Enclosed are the meeting minutes of the second meeting of NRC and DOE/NPO Preparatory to the submittal of the salt site site characterization plan (SCP). The attachments to the minutes are not enclosed since both NRC and DOE already have a complete set. If you have any questions please call Robert Johnson (FTS 427-4676) of my staff.

MINUTES OF THE SECOND MEETING OF NRC AND  
DOE/NPO PREPARATORY TO SUBMITTAL  
OF SALT SITE SCP

JUNE 27-28, 1983  
SILVER SPRING, MARYLAND

Figure 10.2 Test method development (illustrative)

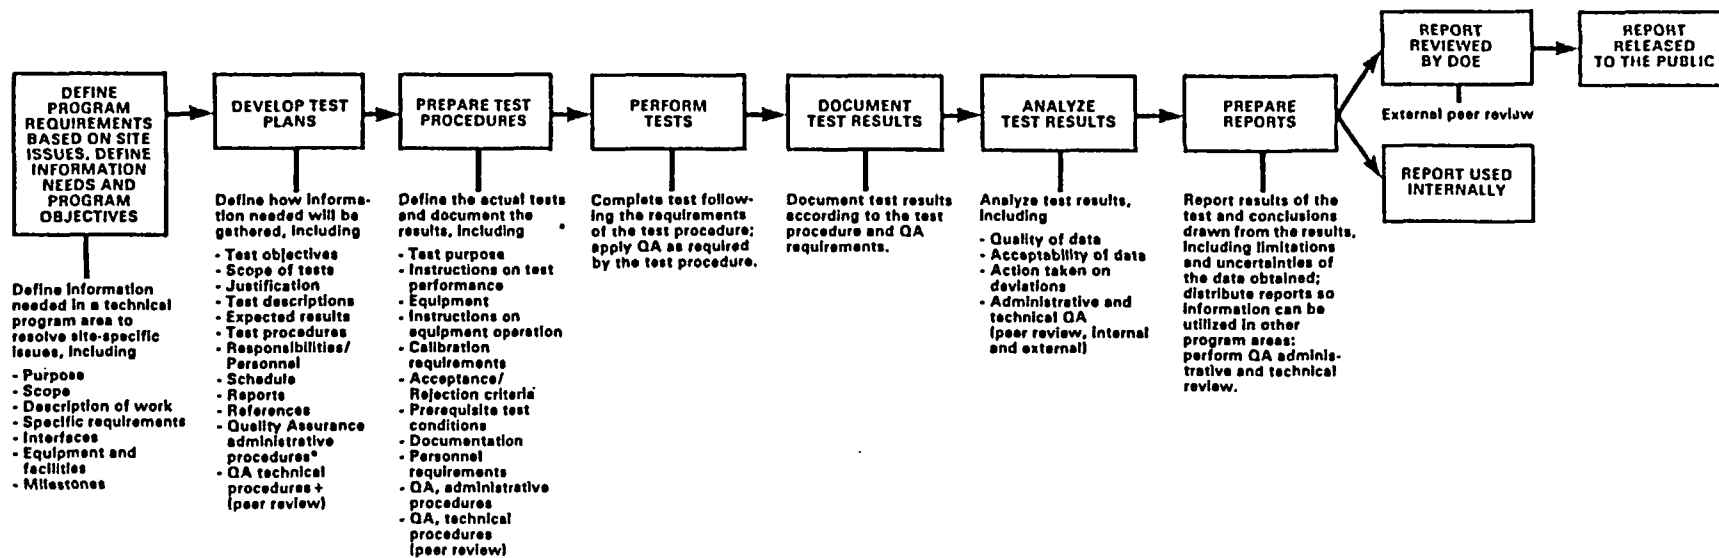
The development of the test plans and test methods is an important element in providing quality assurance for site characterization data. Figure 10.2 illustrates the development and chronology of events in planning and performing a testing program. This also shows the role of QA throughout the procedure, including how QA procedures incorporate reviews by (1) technical management and (2) peer review groups.

Figure 10.2 also illustrates the point where data should be documented (i.e., document test results) prior to analysis of test results. All data should be recorded under full QA requirements at this point in the test program. This data should be available to all interested parties (e.g., NRC, State programs, etc.) for inspection at an early date after it is documented.

Figure 2 ~~Systematic, iterative process~~  
2 Systematic, iterative process  
9-18

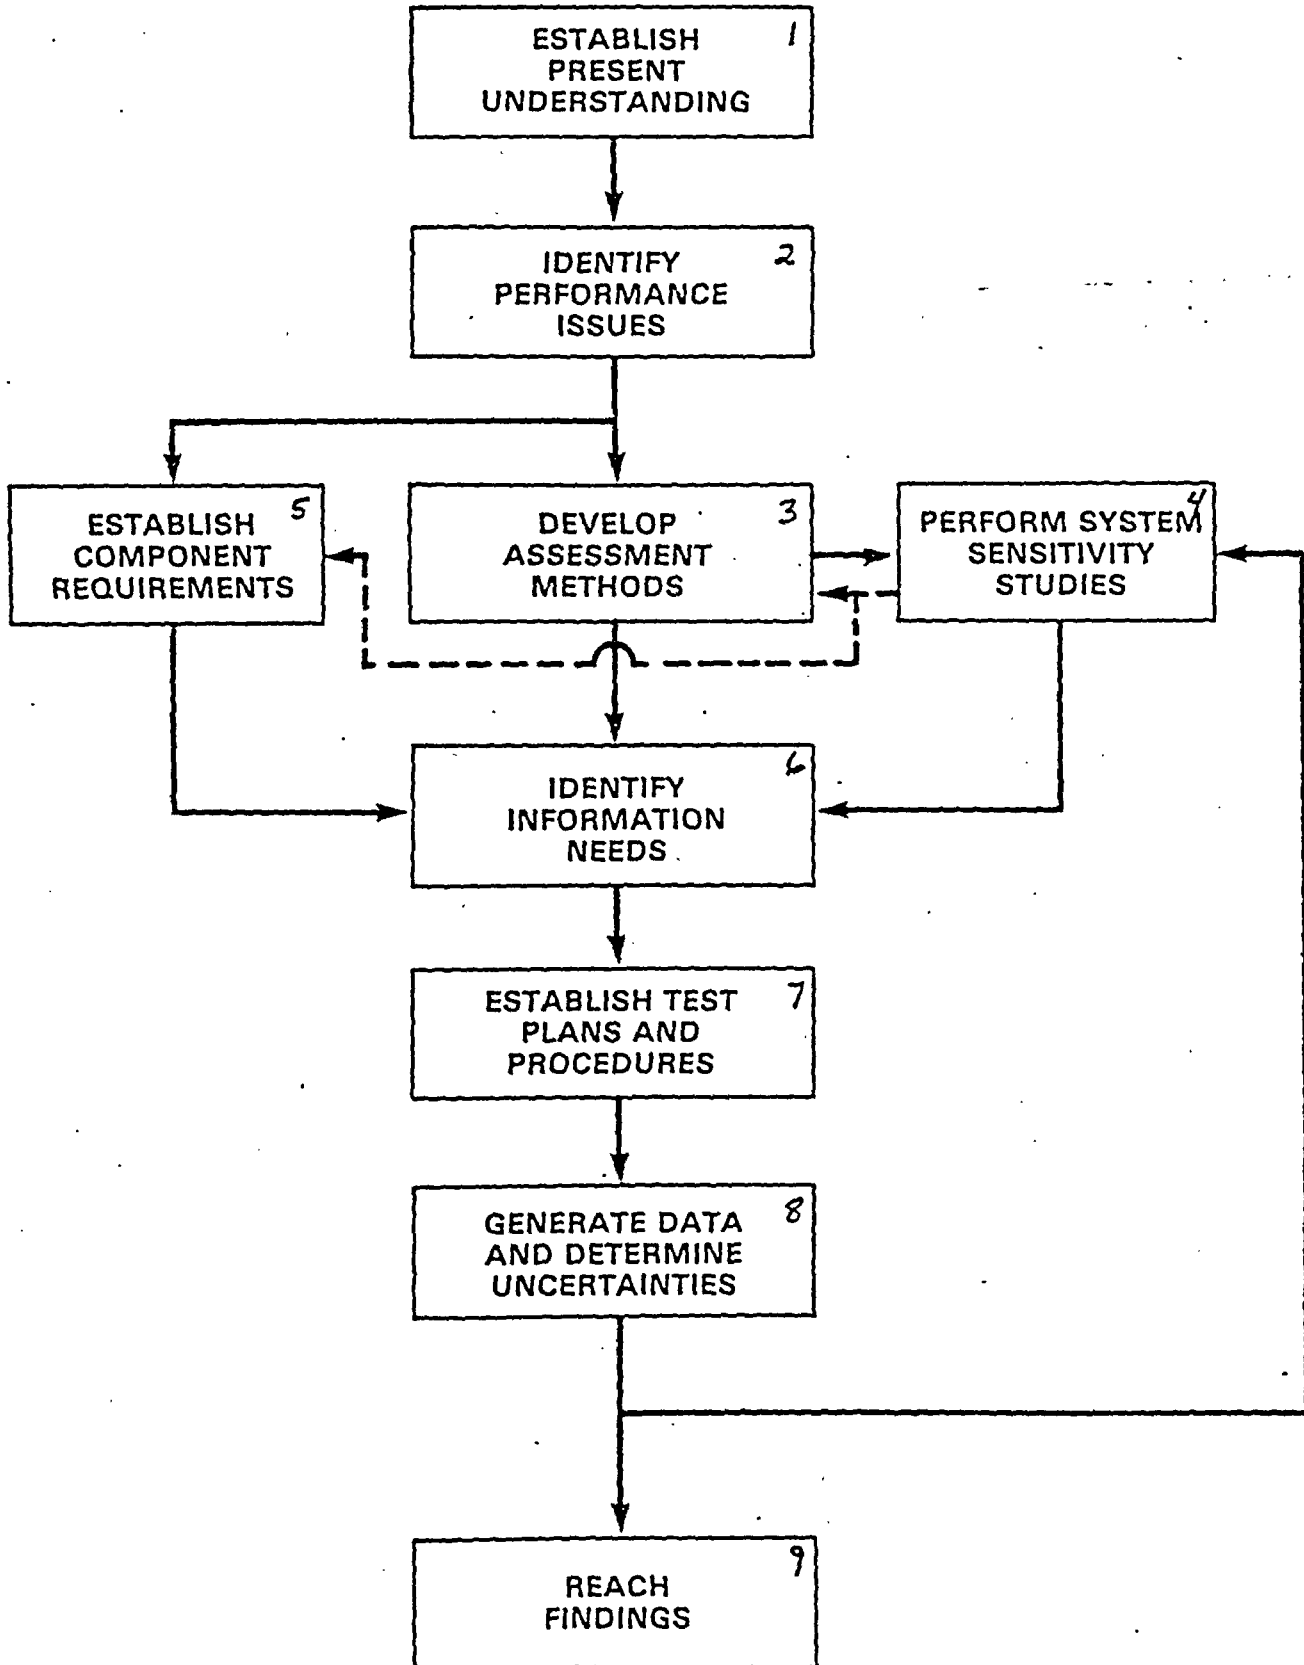
NRC response: DOE is in the best position to weigh all of the factors, including site specific factors and other, non-quantifiable programmatic factors such as cost, to propose what is a realistic and reasonable reliability level. Chapter 9, Figure 9.2, of the BWIP SCA describes the iterative process by which this should most appropriately occur (Attachment 10, figure 2).

Figure 10.1 Technical program control: test plans and procedures (illustrative)

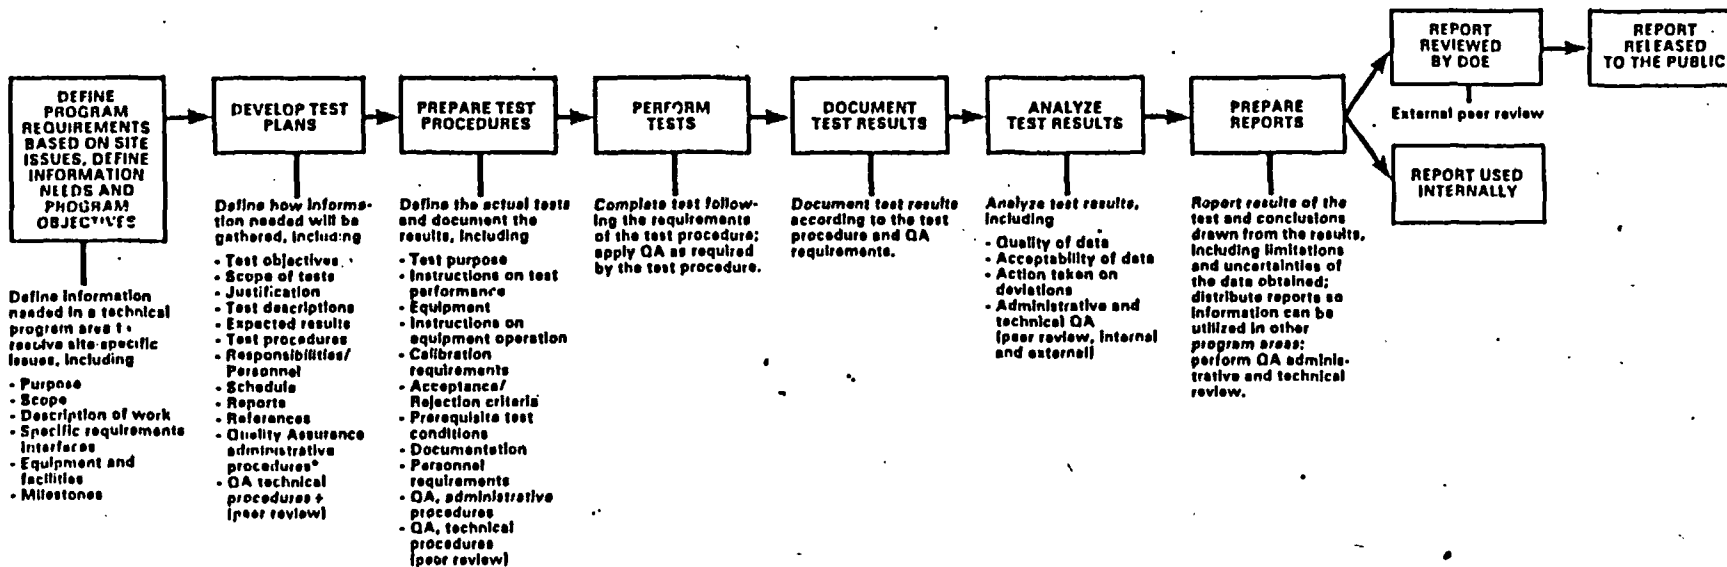
As shown in Figure 10.1, site characterization planning must start by considering EPA and NRC criteria. After a site is selected for further investigation, specific issues are identified, based on regulatory criteria and preliminary evaluation of repository performance.

In reviewing the SCR, the staff generally found that test plans and test procedures were not provided or referenced (see Figure 10.1). The SCR stops at the "information needs" level. The information presented is very general and does not give the staff enough detail to provide comments on test plans. Some procedures have been examined in previous workshops with DOE, but the staff expected this information to be at least referenced in the SCR. The staff recognizes that not all test plans and procedures may be needed at this time. However, some test plans (e.g., exploratory shaft and waste package development testing) should be available for QA review. Each chapter of this Draft SCA includes comments on the level of detail of the plans provided and gives examples of deficiencies.
